Planning Commission Staff Report

Meeting Date: April 11, 2022

Description: **Chesterfield Valley Nursery SDP:** A Site Development Plan, Landscape Plan, Architectural Elevations and Architectural Statement of Design for a 54.97-acre tract of land located along the north side of North Outer 40 Road and east of Boone's Crossing (17T620041).

Figure 6: Site Plan

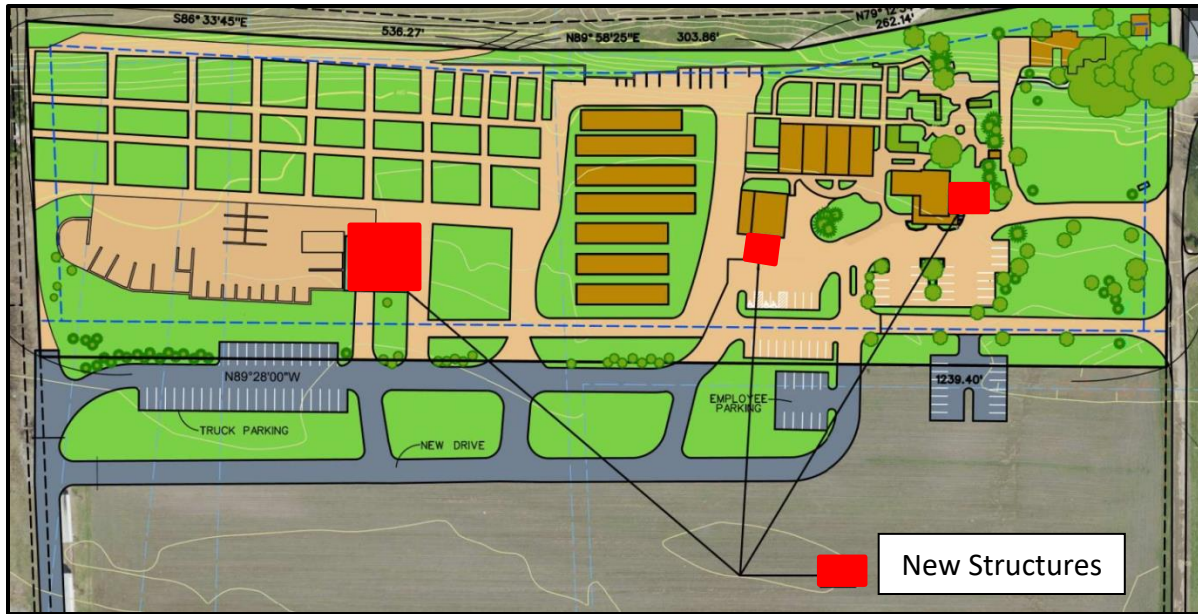
The site is accessed from North Outer 40 Rd. by a gravel drive in the southwest corner of the site. Another gravel drive entrance is located on the east end of the site. Most of the northern area of the site is closed to vehicle traffic as it is used for landscape material storage.

Code requires that all parking and loading areas, including driveways, be paved. Exceptions can be made for both AG and NU districts if the City approves an alternative dustproofing method. Gravel is not considered a suitable dustproofing method as dust carries offsite onto adjacent properties. The Site Development Plan shows calcium chloride-treated gravel drives and parking areas to remain in place in conjunction with this request. Staff is not aware of any approvals of treatment of gravel with calcium chloride as a suitable alternative and recommends that the gravel areas be paved in accordance with the UDC.

Staff has reviewed this proposed development and found it to be in compliance with the City's Comprehensive Plan, Unified Development Code and governing ordinance with the exception of the use of gravel. Staff recommends that these areas be paved. All outstanding comments have been addressed at this time. Staff recommends approval of this Site Development Plan, Landscape Plan, Lighting Exhibit and Architect's Statement of Design.

Figure 7: Landscape Plan

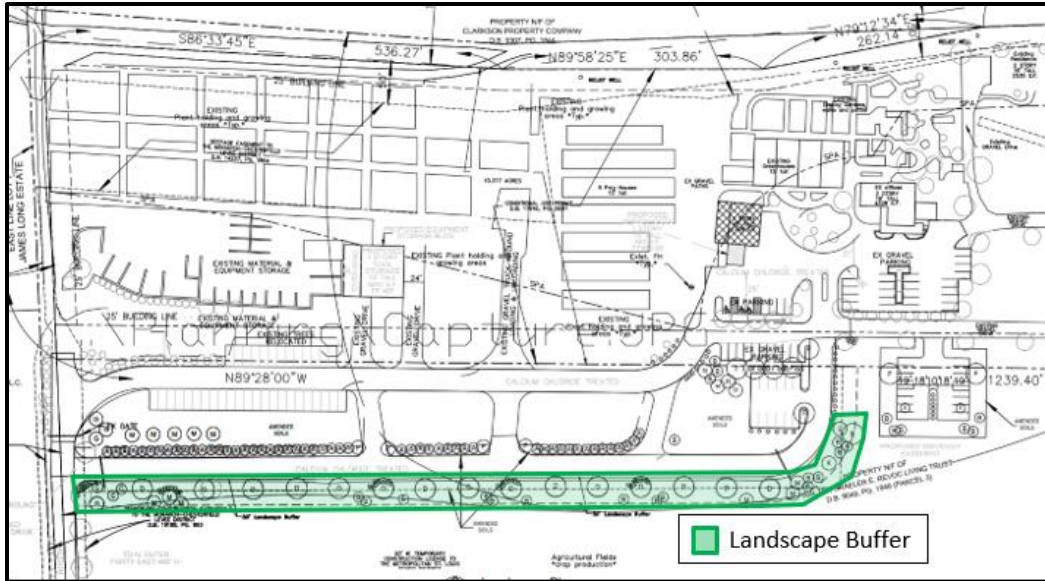
A landscape buffer is required along the south end of this development where the property abuts I-64 and North Outer 40 Rd. The Landscape Plan depicts a landscape buffer along the south side of the parking area and access drive into the site. Since the primary use on the site is a nursery, the inventory of trees and shrubs provides additional greenery throughout the site as well.
